**Project:** LOOKOUT LOTS 2, 4, AND 5

**LA JOLLA SHORES PERMIT REVIEW COMMITTEE MINUTES  
LA JOLLA COMMUNITY PLANNING ASSOCIATION**

### a. 4:15-4:45pm LOOKOUT LOTS 4 & 5 (Previously presented May 2018)

### c. 4:45-5:15pm LOOKOUT LOT 2 (Previously presented May 2018)

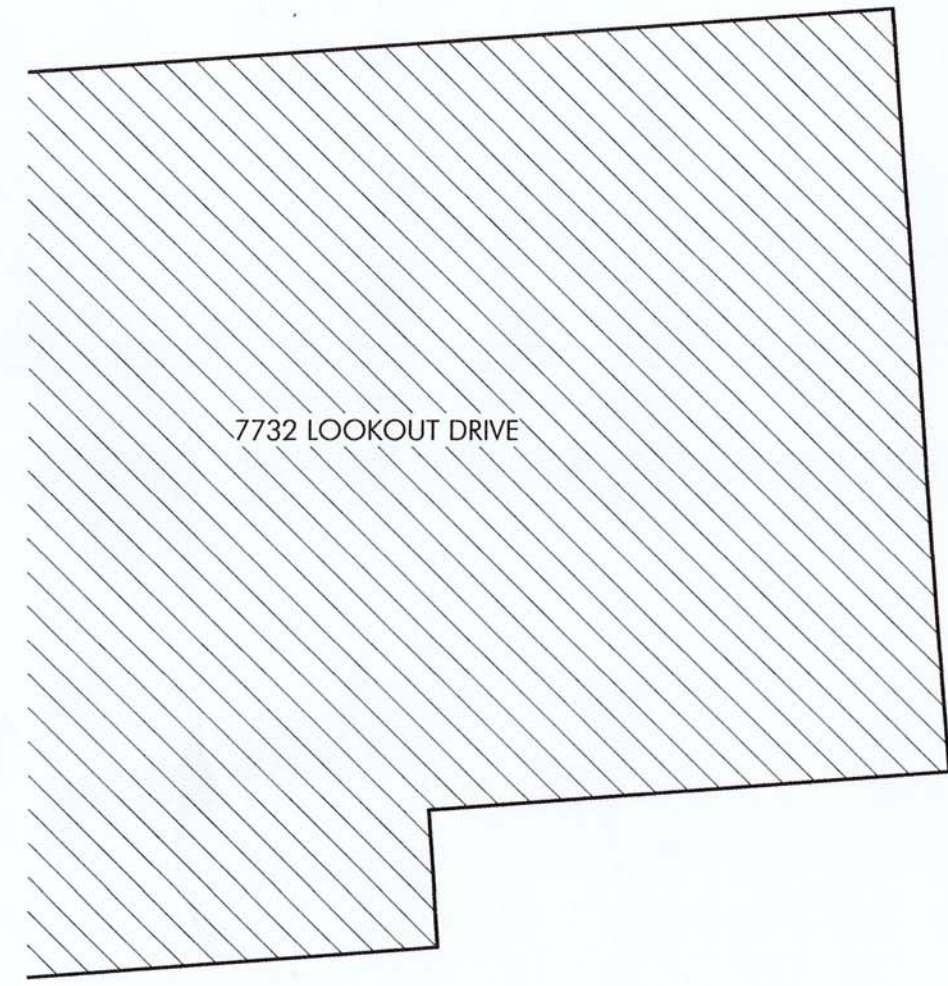
7. Concerns with setbacks, coverage, height, and bulk-and-scale were expressed for all three lots.
  - a. Handout with neighborhood diagram showing all this information was reviewed. Many homes have similar or closer setbacks, the majority are 2+ levels, many were similar FAR

- b. One neighbor pointed out that some of the setbacks for the neighborhood appeared incorrect. It was explained that map was compiled from a certified civil engineering aerial survey of the neighborhood, title report, and city plat maps, along with a visual survey by IA. Neighbor was asked to provide any civil documentation or list discrepancies for further research.
8. Clarification asked regarding square footage calculations. FAR, habitable vs. non-habitable, and basement all explained with garage and gross square footage given verbally.
  9. Concerned with drainage – explained that surface and subterranean drainage were all being addressed by Civil Engineer and will conform to city standards with no drainage across property lines.
  10. Concern with parking – All projects will conform to city parking requirements for parking impact zone.

# LOOKOUT - LOT 2

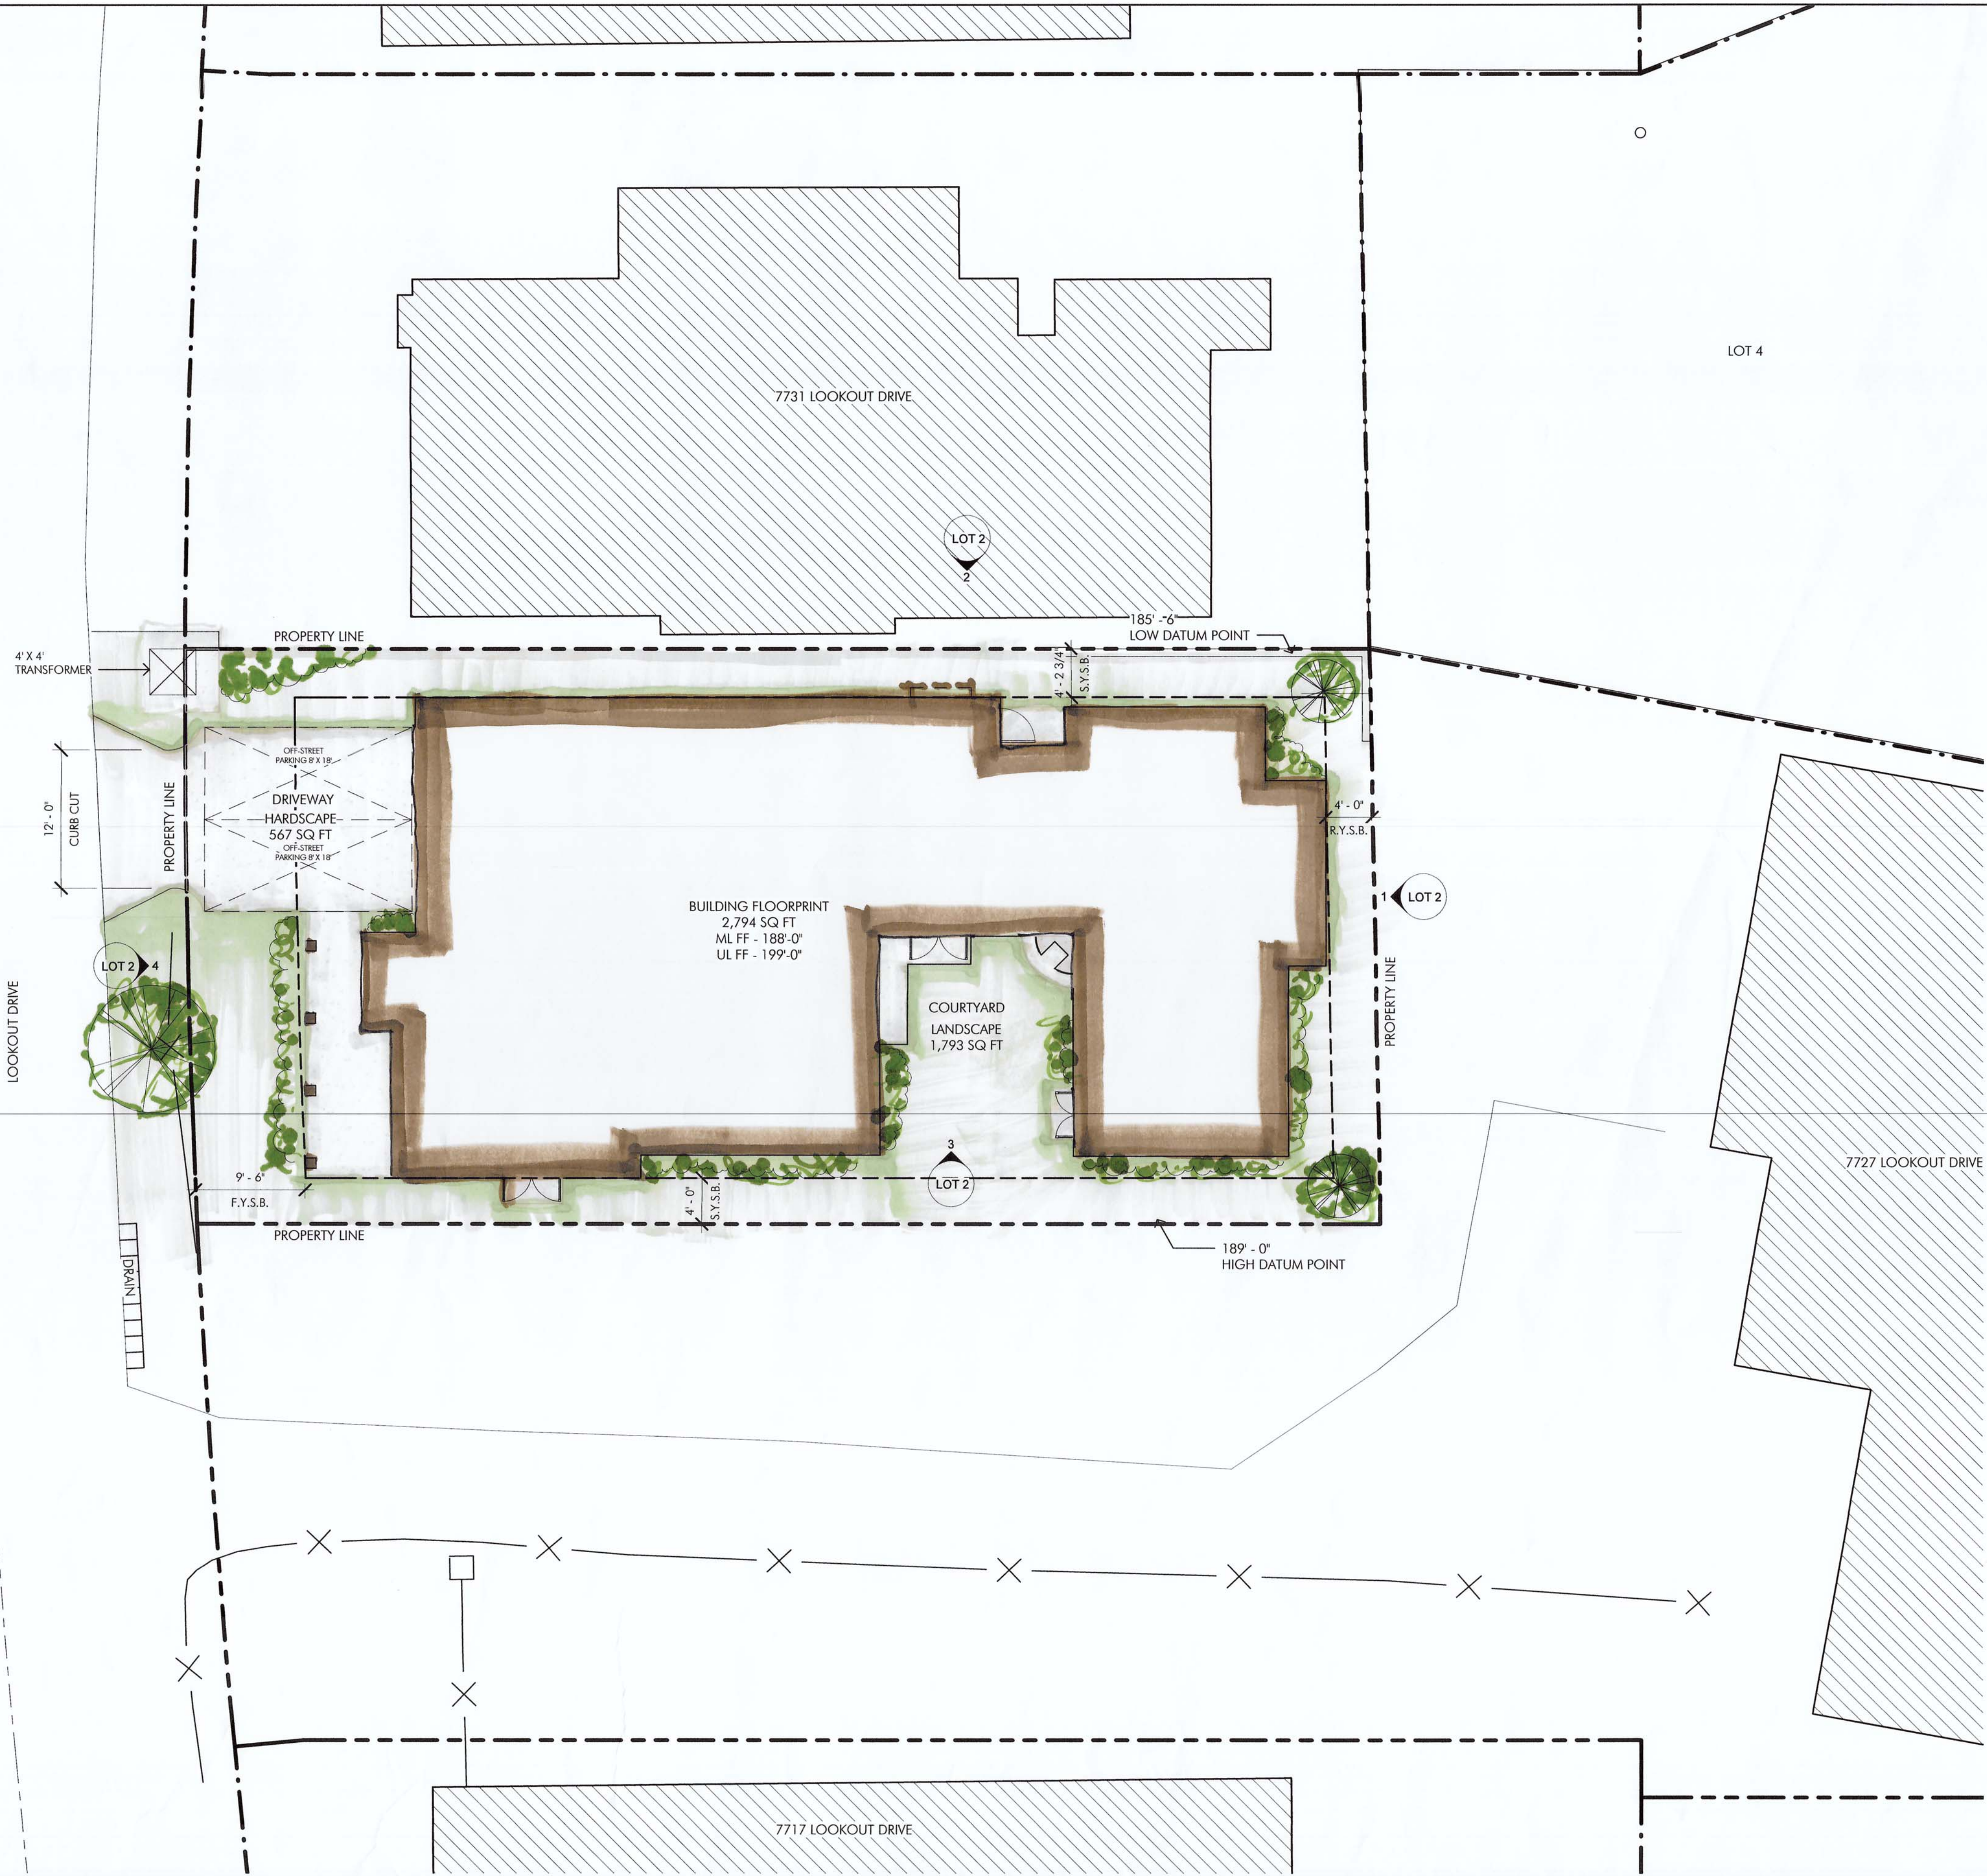
11. Accusation that lot was graded up to increase with the height of the home on Lot 2. It was not, and house is well under height. Owners are addressing grading notice of complaint with City Inspector.
12. Questions about the lot line adjustment.
  - a. Proposed adjustment will allow landscaping buffer, allow for window on east wall of bedroom, and bring coverage into conformance.
13. Due to westerly neighbor's solid 2 story mass with only 1'-3" to 2' SYSB, this side of the proposed house is greatly articulated with second story set way back from both front and side setbacks to allow for ample light and ventilation.

- c. **Desiree Kellogg:** (7728 Lookout Drive) Claimed lots were created after 1972 and the La Jolla Shores PDO applies, specifically paragraph 1510.0304(a) and La Jolla Community Plan, page 89, code and zoning issues, living space vs out buildings (ie garage). Concerned about drainage from lot 2 and adequacy of storm drains.

- d. **Sue Pruitt:** (7731 Lookout Drive) concerned about 2' of added soil to the rear of the property. "Are you using original pre-existing grade?"
- e. **Sue McKean:** (7809 Lookout Drive) Concerned about retaining wall on her property line.
